## PLANNING COMMISSION MEETING

## PLANNING COMMISSION STAFF REPORT EXHIBIT "A" FINDINGS OF FACT

**Application Number:** 2015-03-MOD

**Application/Proposal:** A request to consider a modification to an existing design review (application number 2013-31-DR) to eliminate an entrance facing NE Halsey Street that was required by a conditional of approval to keep this entrance open during all business hours for a Veterans Affairs outpatient clinic.

**1 TI - FLOOR PLAN - OVERALL**  
A2.11 | 1/8" = 1'-0"

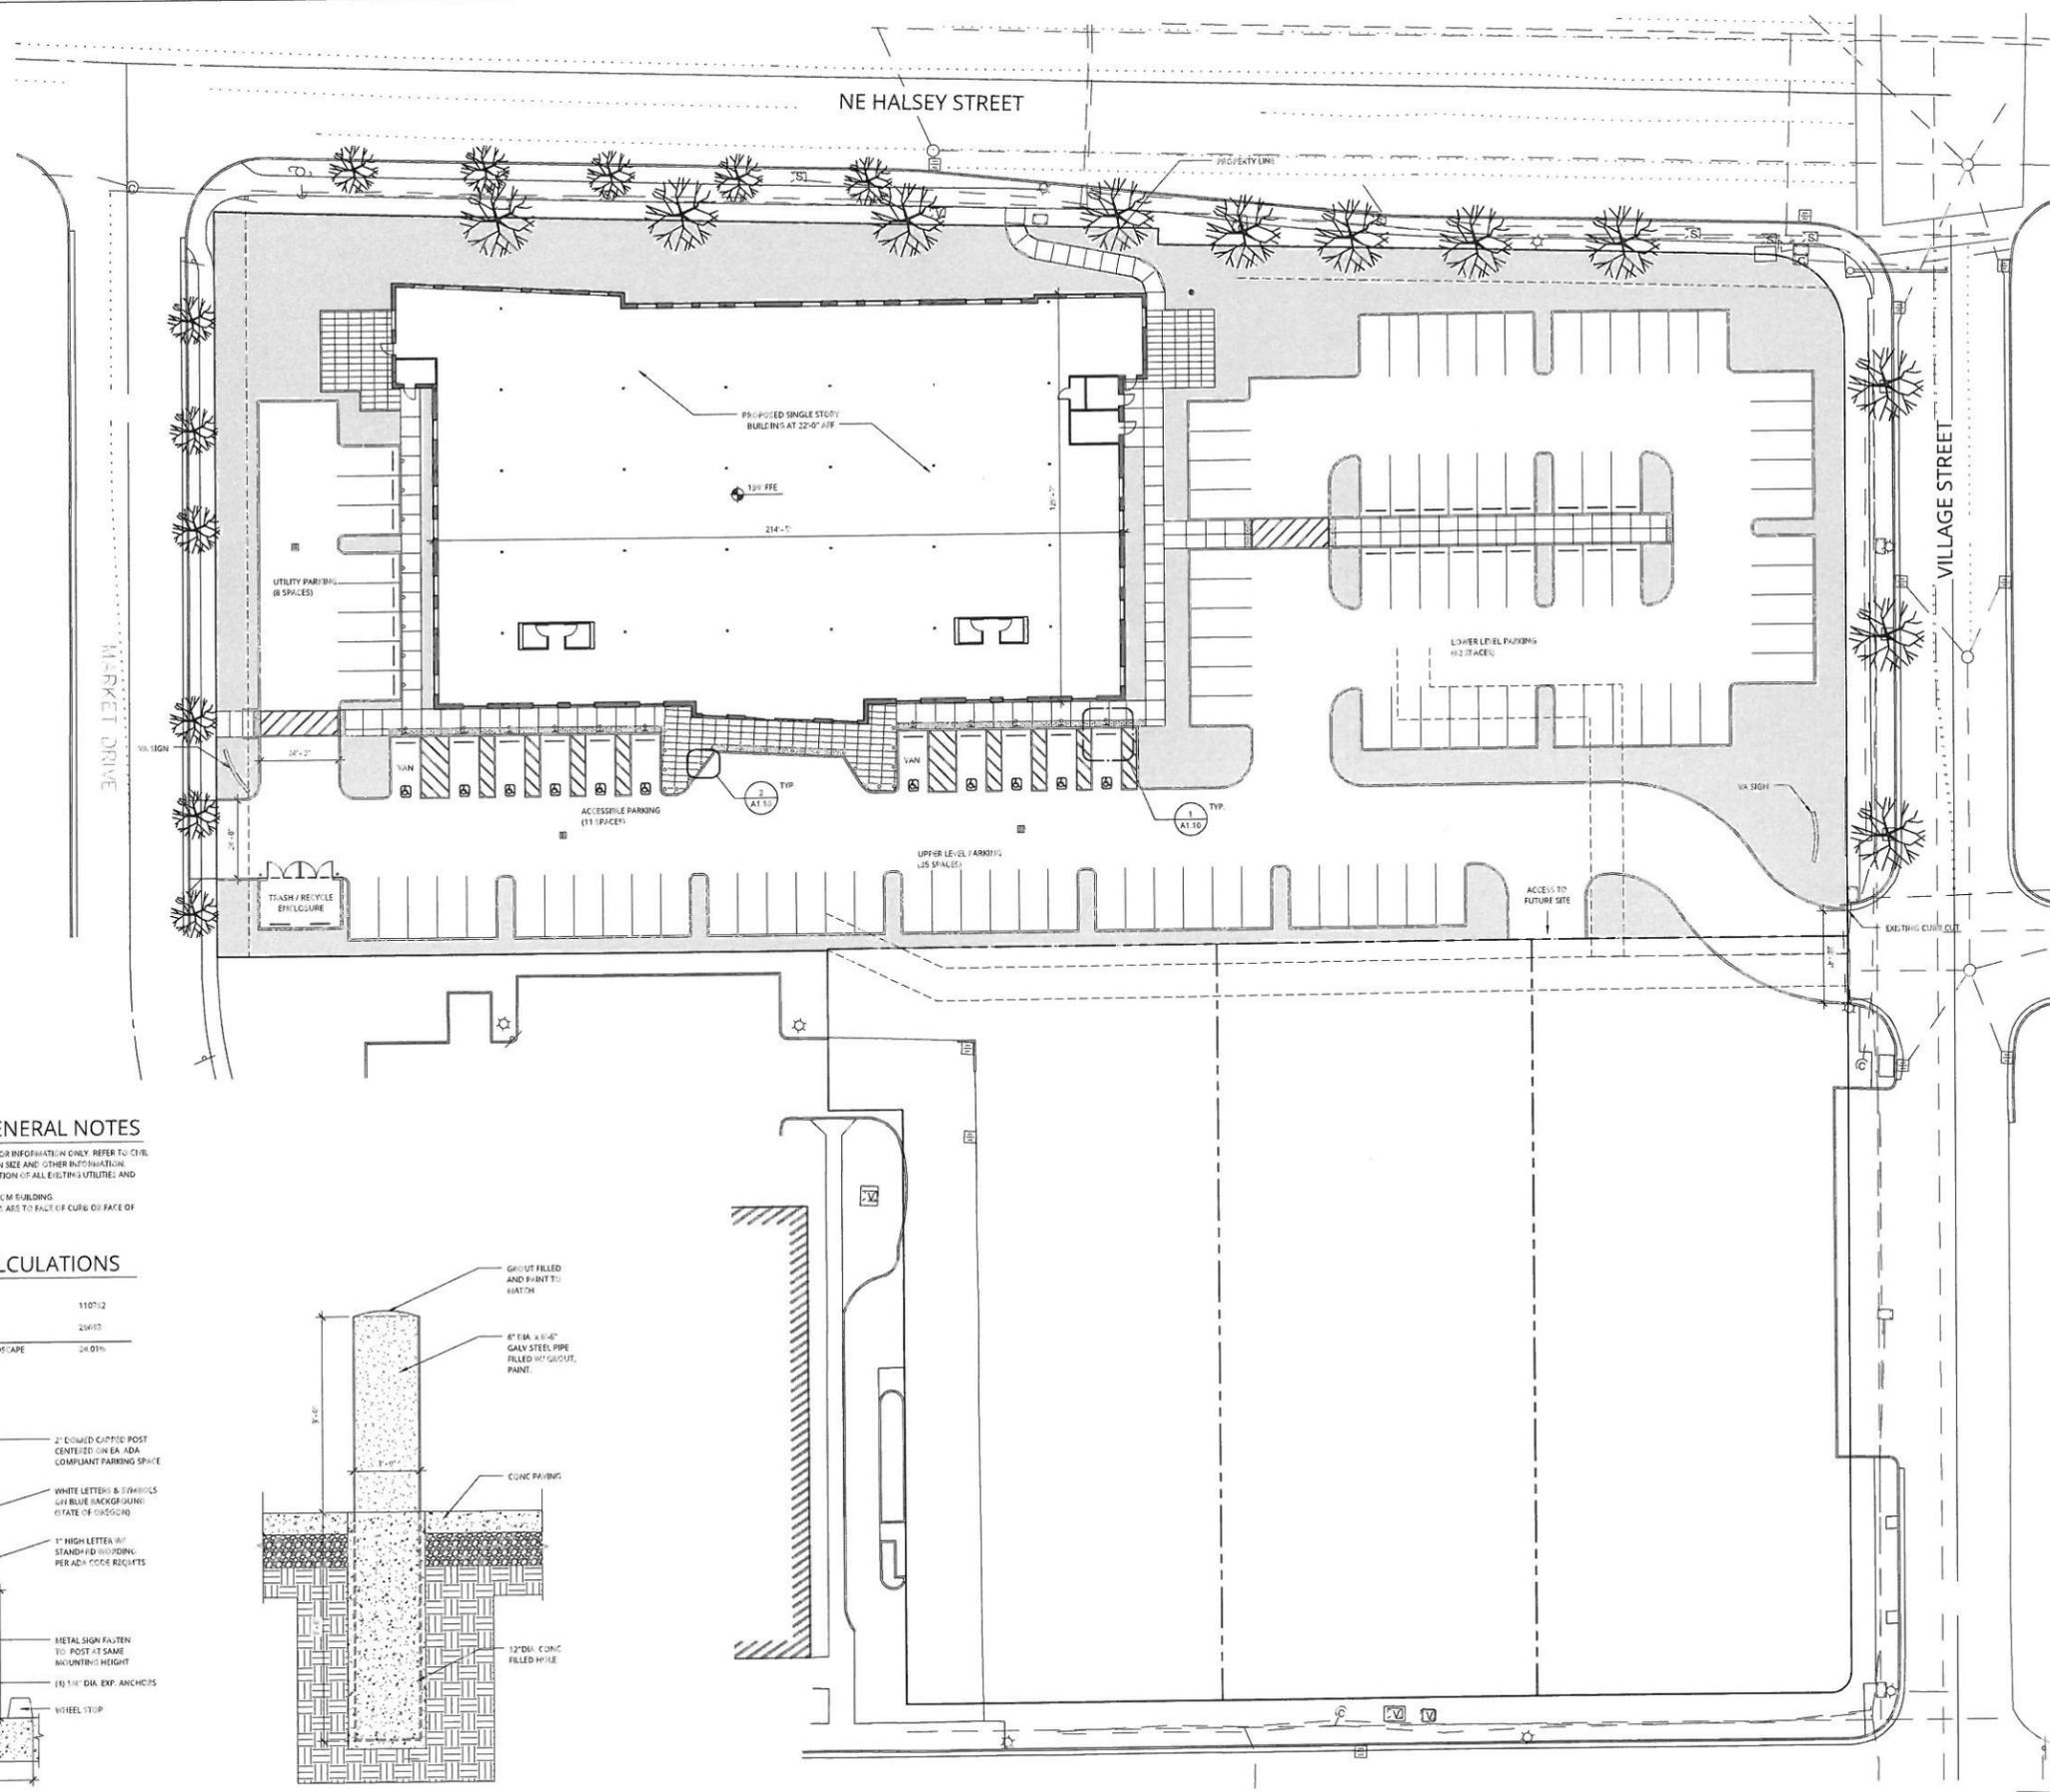
**STAFF COMMENTS:** The tenant of the building (Department of Veteran’s Affairs) has a floor layout (See Exhibit D, Tenant Improvement Floor Plan) for the building which would not allow for a public entry on the North side of the building. The tenant is proposing one entry for the clients of the clinic to use that is accessed from the parking lot area and for this to be considered the “primary entry”.

WE wouldn't be able to provide a law enforcement perspective, since that is beyond our responsibilities. However, by eliminating the entrance they may be eliminating a required exit from the interior. They may not meet the required exiting rules without it. That comes out of the Oregon Structural Specialty Code so Steve Winstead would review that requirement.

**3 SITE PLAN**  
A1.10 | 1" = 20'-0"

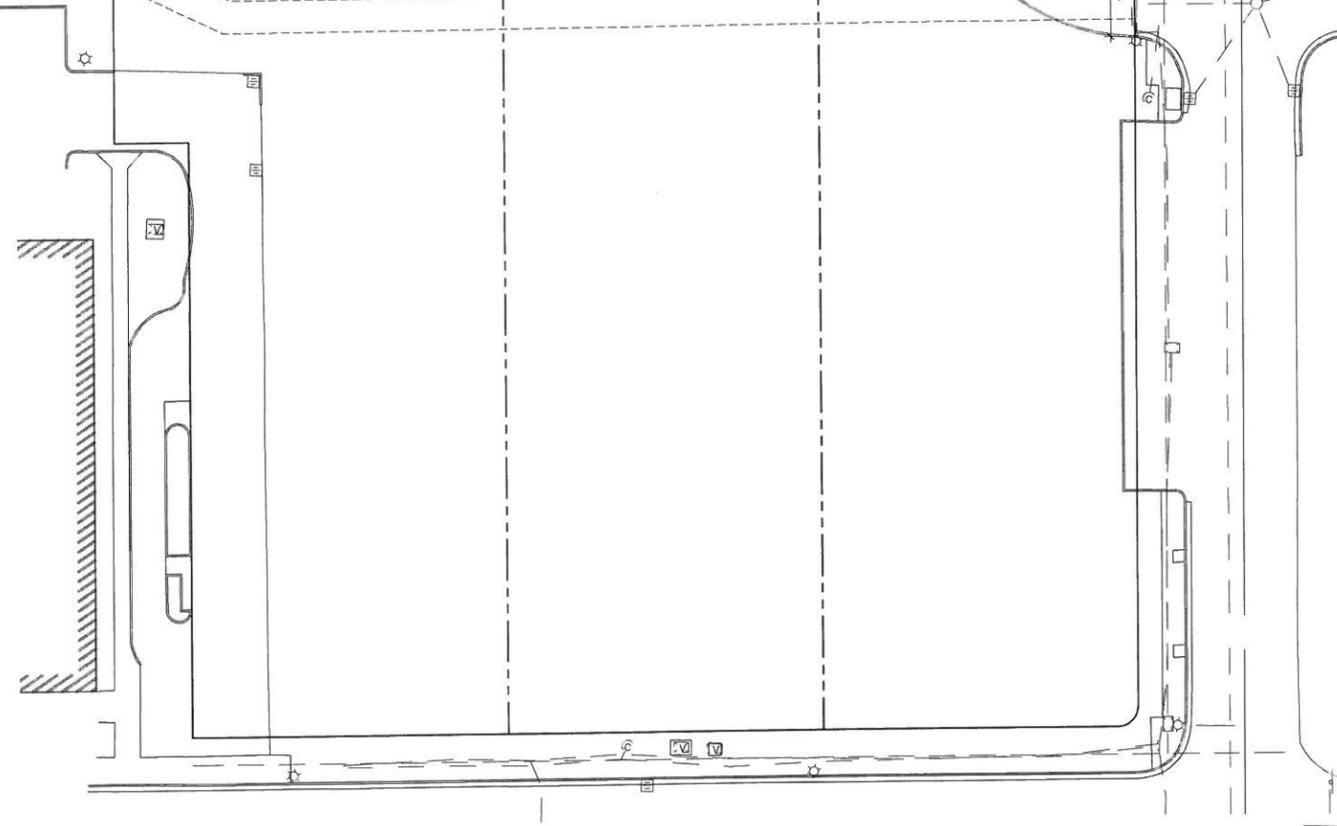
The proposed modification would eliminate the “primary” entry facing Halsey Street that is accessed from the public sidewalk. It would make the “secondary” entrance on the South facing side of the building the “primary” entrance for all clients using the building. The site plan shows that the South facing entrance is accessed from a pedestrian pathway that leads to the public sidewalk on NE Halsey Street (See Exhibit E, Site Plan).

**STAFF COMMENT:** The approved Planning Commission site design review (August 28, 2013) reviewed pedestrian access and circulation. No pedestrian pathways have been removed. Pedestrians and cyclists will be able to utilize the proposed south entryway from an internal pathway around the building from NE Halsey Street.

**FINDINGS: Removing the “primary” entrance on Halsey Street will not have significant impacts to transit riders, pedestrians or cyclists. In removing the “primary” entrance on Halsey Street Condition of Approval #16 in the Planning Commission’s approved site design application (August 27, 2013) is no longer applicable. A pedestrian pathway is proposed from NE Halsey into the site and follows the building to the proposed main entrance on the south side that will be open during business hours. The Comprehensive Plan describes this area having uses that are automobile-orientated with parking areas to support economic viability. The proposed modification does not conflict with the intent of the Comprehensive Plan’s vision/description for this area.**
